Appendix IV

NRC Staff Computational Fluid Dynamics Simulations in Support of the SONGS Audit

**Figure 1: Baseline Case
Containment Pool Velocity [ft/s]**

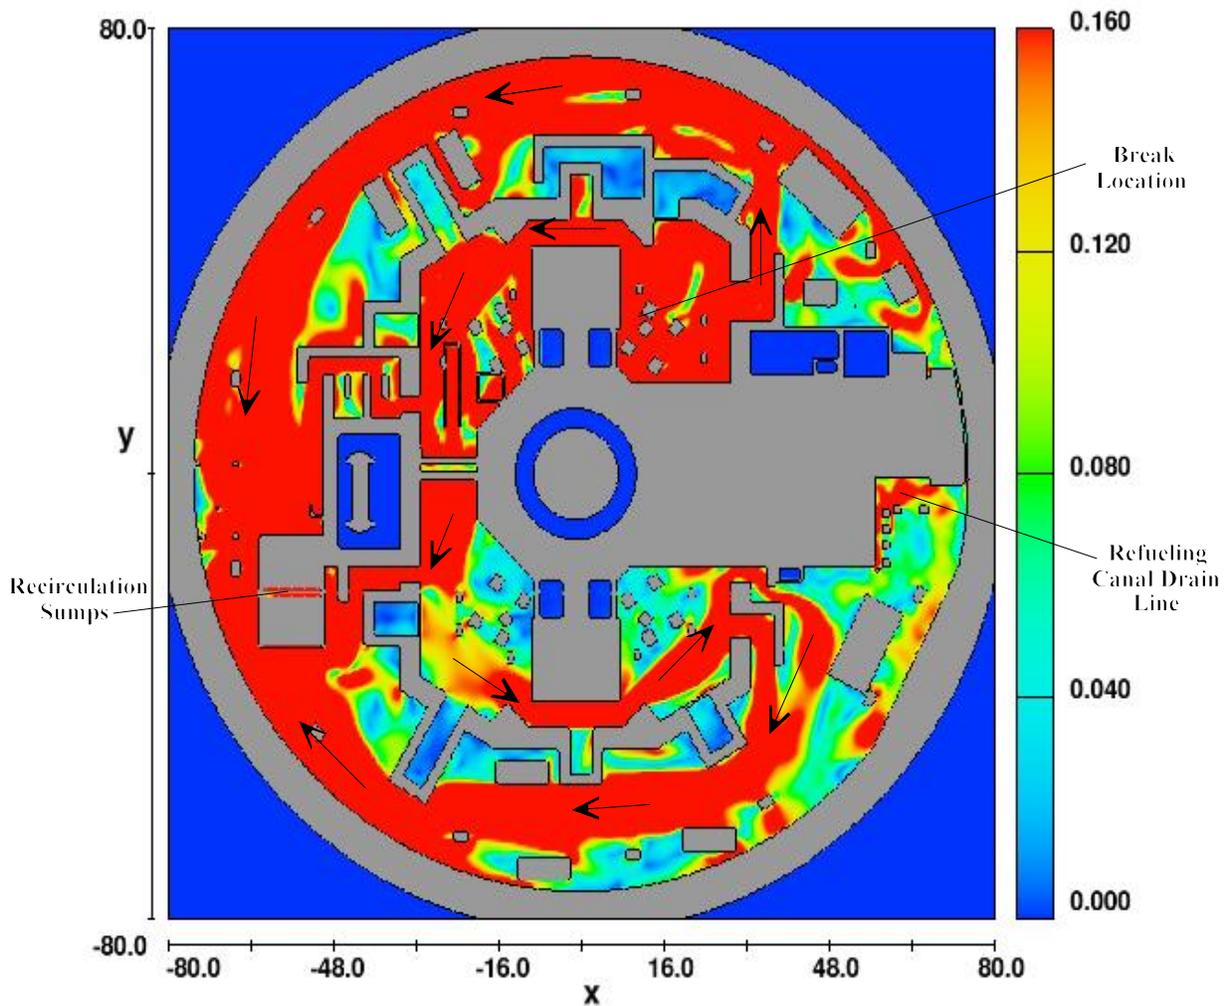
The staff observed that Figure 1 corresponds closely to the analogous figure the licensee generated for Case 1 in the debris transport calculation (Figure 5.9.11) [1]. While this result is expected based upon the fact that no substantial changes were made to the input deck, it confirms that the licensee's results can be essentially replicated on a different computational platform.

**Figure 4: Reduced Pool Temperature Case
Containment Pool Velocity [ft/s]**

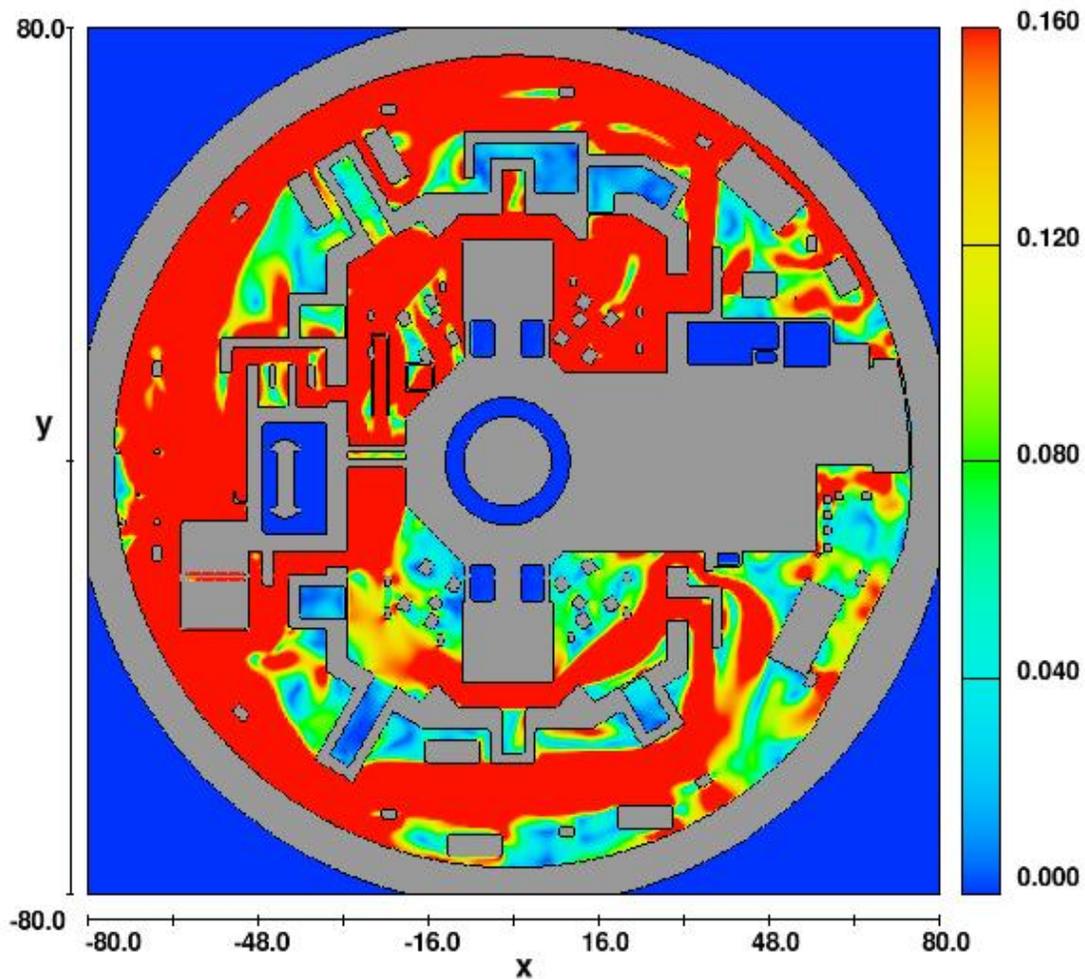
No significant differences were observed from a comparison of the results of the Reduced Temperature Case (Figure 4) to the Baseline Case (Figure 1). The few subtle differences between the two cases may result from fluctuations in the code predictions on the approach to a steady-state solution. The results of the reduced temperature simulation indicate that, barring changes to the physical properties of the debris in the containment pool, the debris transport results are not likely to change significantly as the result of expected changes in fluid temperature and temperature-dependent fluid parameters such as viscosity.

**Figure 5: Southeast Passage Blockage Case
Containment Pool Velocity [ft/s]**

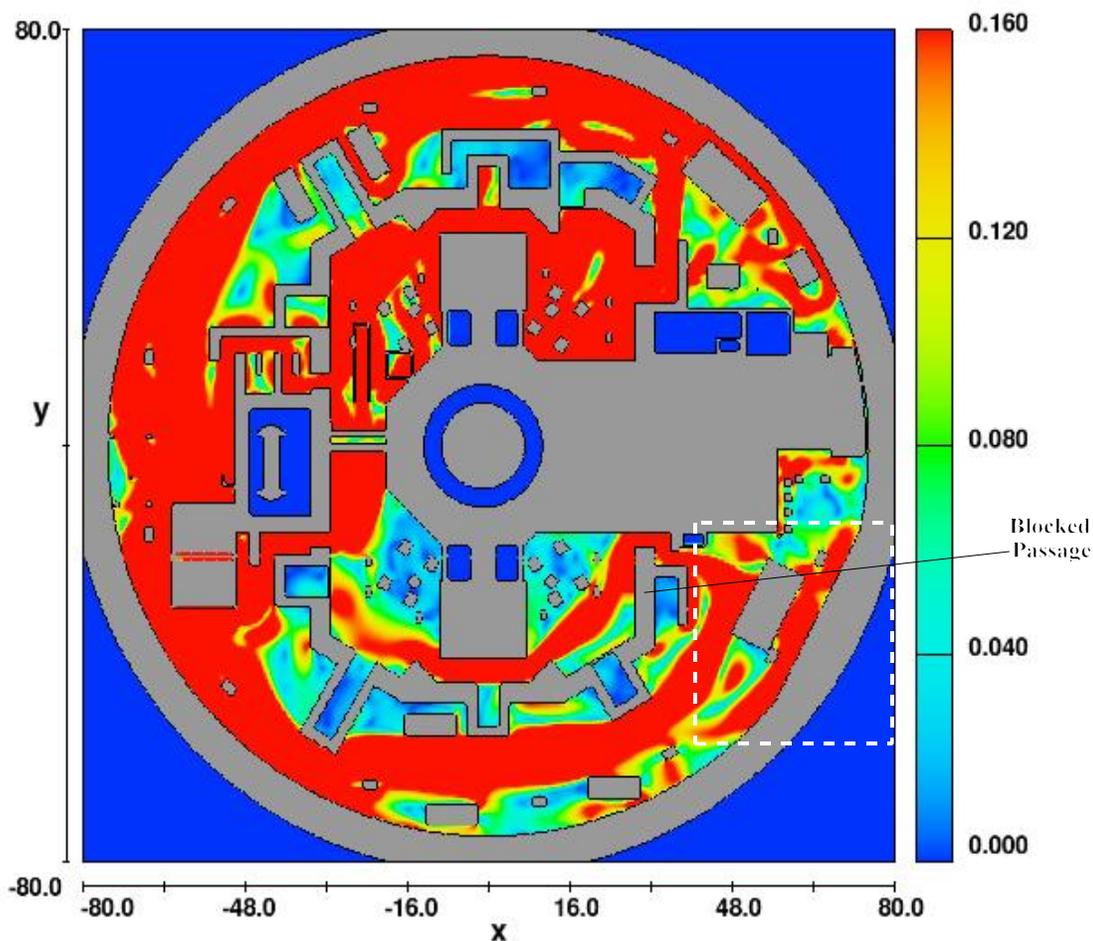
The results of this sensitivity simulation are generally consistent with the licensee's judgment that explicitly modeling blockage at the lower southeast passage of the Loop 2 compartment would not significantly alter the containment flow field. However, by comparing the flow velocities in the southeast quadrant (i.e., lower right corner) as well as other areas of Figures 1 and 5, local perturbations are obvious. A dashed-line box is provided on Figure 5 to emphasize the most obviously perturbed local area. Other changes are also apparent, some of which were likely due to the additional 200 seconds of run time as compared to the baseline case, and which will be addressed subsequently as part of the Case 1-8 discussion.

Based upon SONGS-specific characteristics, including the geometric layout of the containment and analytical assumptions such as the assumed spatial distribution of debris at the initiation of sump recirculation (refer to Section 3.5.3.1 of the main report), the staff concluded that the containment pool flow field perturbations associated with this sensitivity case are not sufficient to impact the overall debris transport results for the Case 1 break. The staff further considered the potential for blockage at this passageway for Case 2 break conditions, as described subsequently in the discussion of Case 2-2 and Case 2-3.

Figure 6: Elimination of Containment Spray Alternating Horizontal Velocity Component Case, Containment Pool Velocity [ft/s]

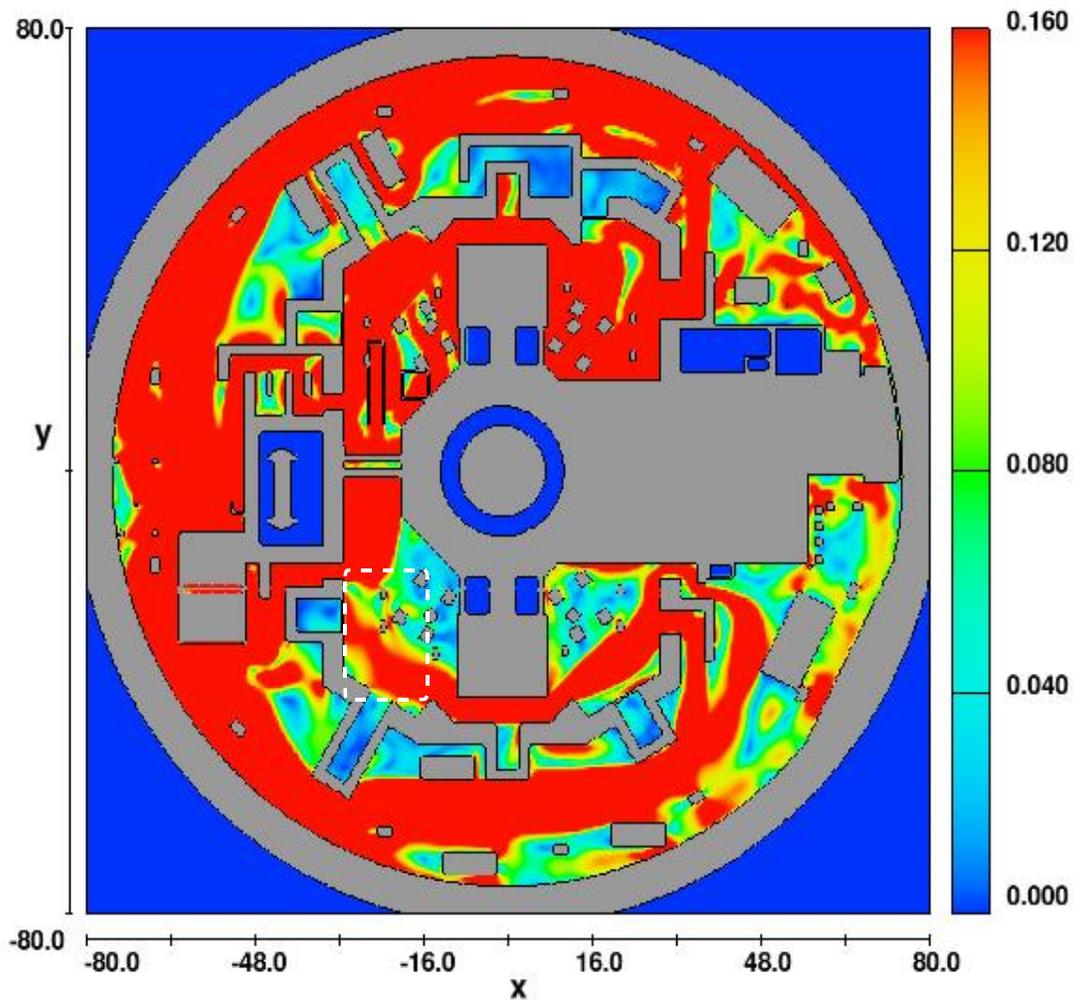
A comparison of Figures 1 and 6 reveals only minor differences. The most significant of these minor differences appear to be attributable to differences in the simulation time (i.e., Figure 1 is based on a 300-second run and Figure 6 is based on a 500-second run) rather than the elimination of the horizontal component of the spray vector (which can be appreciated subsequently in the discussion of Extended Simulation Time Case, Case 1-8). One such difference is enclosed by the dashed-line box on Figure 6. The staff's comparison of Figure 1 and the Case 1-4 simulation results at 300 seconds (plot not included in this appendix) show that velocity predictions for the area within the dashed-line box are essentially equivalent. The effects of extending the simulation time will be examined in more detail in the discussion of Case 1-8.

In addition, the staff notes that the predicted flow field in the locations where containment spray is introduced to the model, particularly the regions near the containment wall on the west and south (i.e., left and bottom) of the containment pool, does not appear to be significantly affected by the removal of the horizontal velocity component (the containment spray flow addition locations for the CFD model are summarized in Section 3.5.4.1 of the main report). Based upon the assumptions made by the licensee for the spatial distribution of debris at the initiation of sump recirculation (refer to Section 3.5.3.1 of the main report), the staff concluded that the minor differences observed between Figures 1 and 6 would not appreciably impact the overall transport results.

**Figure 7: Increased Containment Spray Flow Case
Containment Pool Velocity [ft/s]**

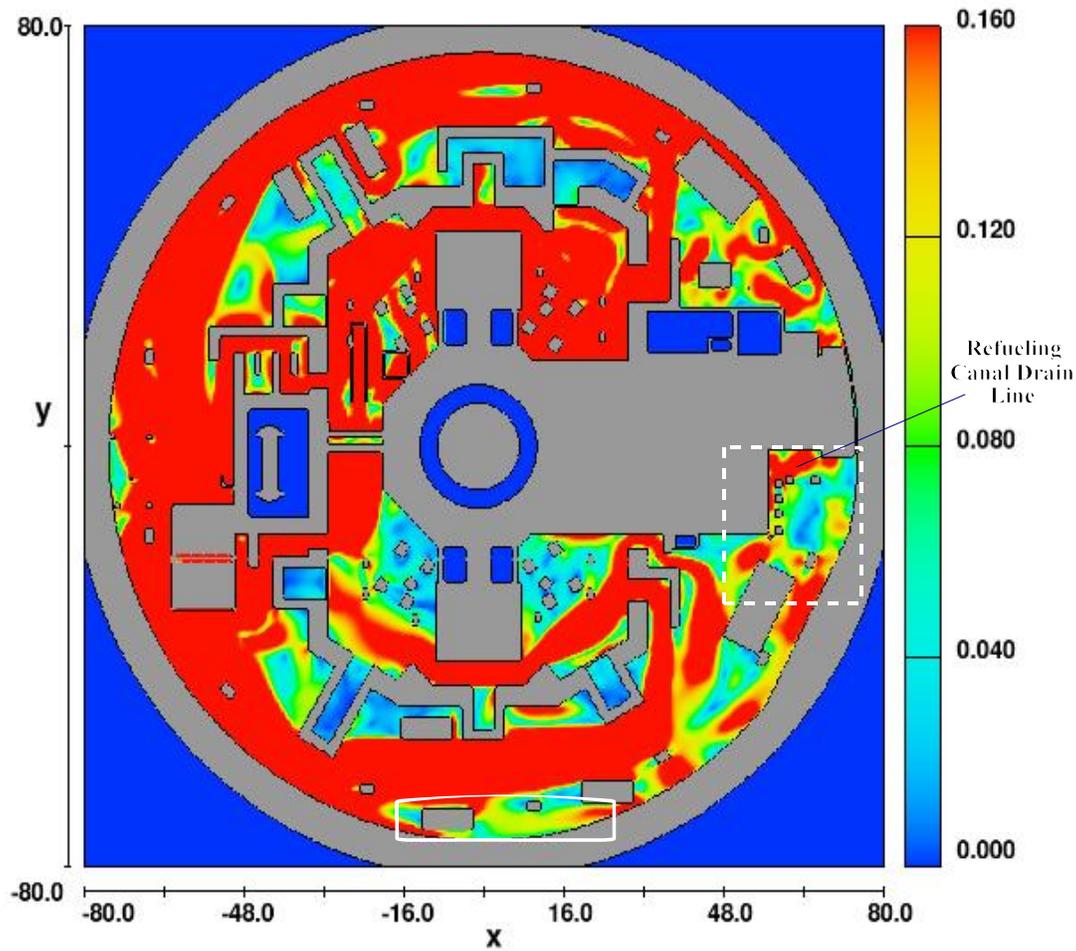
As may be observed from a comparison of Figures 1 and 7, the 20% increase in total containment spray flow does not have a significant impact on the overall containment flow pattern. However, slight increases in velocity magnitude are visually apparent in several areas.

In particular, the staff focused upon one of these areas in the upper southeast quadrant of the containment pool, which is enclosed inside a dashed-line box on Figure 7.

Velocity increases within the dashed-line box on Figure 7 are of potential significance because the refueling canal drain line is located within the red-shaded area near the upper center of this box. As noted in Section 3.5.1 of the main report, 22% of washed-down debris is modeled as entering the containment pool through the refueling canal drain line. For the baseline case simulation depicted in Figure 1, it can be inferred that any small pieces of debris entering the containment pool via the refueling canal drain line would tend to settle because the velocities in this region do not exceed 0.16 ft/s (refer to the discussion of transport metrics in Section 3.5.3.2 of the main report). However, Figure 7 shows that, when the total containment spray flow is increased by 20%, the licensee's metric for tumbling transport of small pieces of mineral wool (i.e., 0.16 ft/s) is approached in the vicinity of the refueling canal drain line, although it does not appear to be exceeded along a continuous path to the recirculation sumps.

A solid-line box is also depicted on Figure 7, which highlights an area near the south wall of the containment wherein small pieces of mineral wool debris would generally not have sufficient velocity to reach the recirculation sumps. This area is highlighted because a significant quantity of containment spray drainage and entrained washed down debris are assumed to enter the containment pool within this area, as well as the region immediately surrounding the box (refer to Sections 3.5.3.1 and 3.5.4.1 of the main report). Although the simulated increase in spray flow slightly reduced the size of the enclosed low-velocity area, due to the presence of several flow obstacles the flow field changes in this area are not sufficient to significantly affect the overall debris transport results.

**Figure 8: Increased Refueling Canal Drainage Flow Case
Containment Pool Flow Velocity [ft/s]**

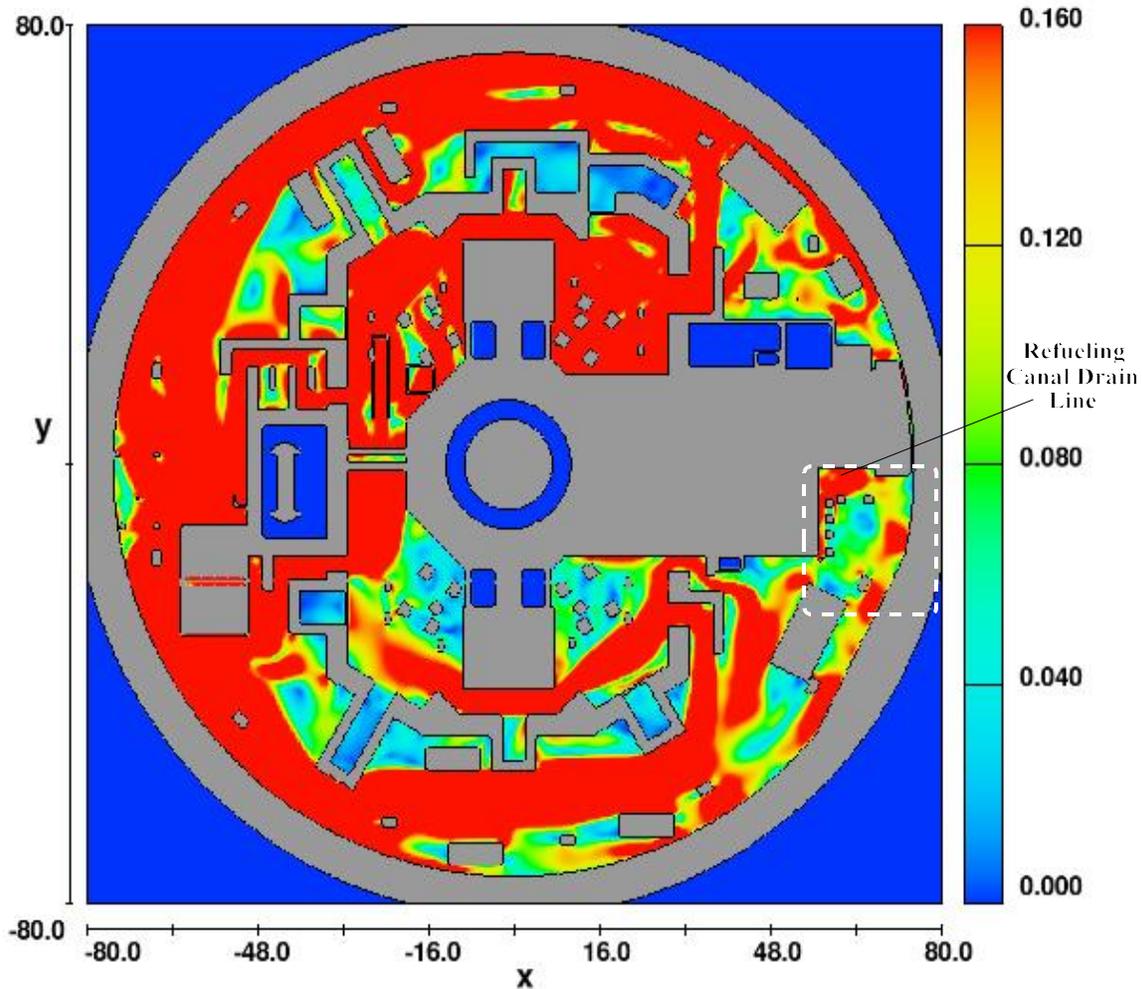
As expected from the results of the previous case, the overall containment flow pattern is not significantly affected by the increased refueling canal drainage flow. However, similarly to the previous results shown in Figure 7, increased local velocities are noted in Figure 8 inside the boxed area in the vicinity of the refueling canal drain line. These local velocities appear to be closely approaching the 0.16-ft/s metric at which the licensee assumed that small pieces of mineral wool can transport along the containment floor by tumbling. However, it is noted that, once again, the assumed transport metric is not exceeded along a continuous path from the refueling canal drain line to the recirculation sumps.

Based on the results of Cases 1-5 and 1-6, the staff concludes that reasonable uncertainties in the spray drainage pattern described in Section 3.5.4.1 of the main report would not likely result in a non-conservative impact on the overall debris transport results.

**Figure 9: Increased Computational Mesh Resolution Case
Containment Pool Velocity 1 Inch Above Floor [ft/s]**

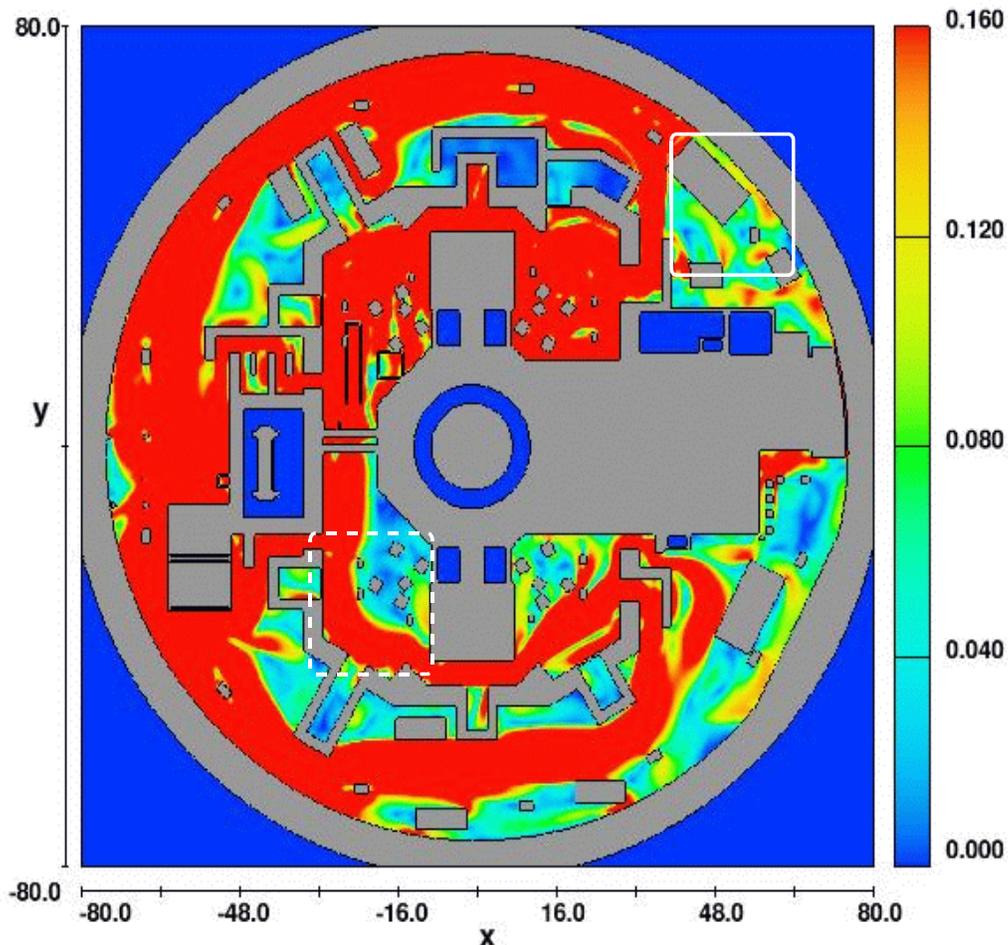
The overall flow pattern depicted in Figure 9 is similar to that shown for the baseline results in Figure 1. However, several noteworthy differences are apparent, the most significant of which is highlighted inside a dashed-line box located on the southwest side of the Loop 2 compartment. On Figure 9, the flow within the dashed-line box appears to be concentrated along smooth streamlines hugging the outer compartment wall. In contrast, the flow in this region on Figure 1 appears diffuse and is not well-developed, presumably having been disturbed by small obstacles in the loop compartment.

A second noteworthy difference can be observed in the upper northeast quadrant of the containment pool, within the solid-line box near the containment wall. The predicted flow between the large rectangular obstacle and the containment wall is significantly reduced in Figure 9 as compared to Figure 1. Other more subtle changes in the flow pattern can also be observed for the increased mesh resolution case, particularly in areas where obstacles are present.

The differences between Figures 1 and 9 can be primarily attributed to the difference in the resolution of their respective computational meshes. In particular, the increased resolution of the mesh used to generate Figure 9 likely permitted both the containment geometry and the pool flow characteristics to be represented more accurately. However, a secondary cause of the differences is the fact that Figure 9 is based on a 700-second simulation, whereas Figure 1 was based on a 300-second simulation. The increased simulation time likely allowed the flow pattern in Figure 9 to approach steady-state conditions more closely than the baseline case. Additional examination of extending the simulation time of CFD runs is provided below in the discussion of the following sensitivity case (Case 1-8).

Based upon the assumptions made by the licensee (particularly the assumed initial spatial distribution of debris and the assumed lack of debris settling in Loop 2), the changes in the predicted containment pool flow pattern attributed to the increased mesh resolution did not lead to the identification of non-conservatism in the SONGS analysis. However, the change in the predicted flow in the southwest part of the Loop 2 compartment (highlighted again in the dashed box on Figure 10) could be important for other plant containment geometries and post-accident conditions, which demonstrates the potential significance of mesh resolution on the predicted flow pattern.
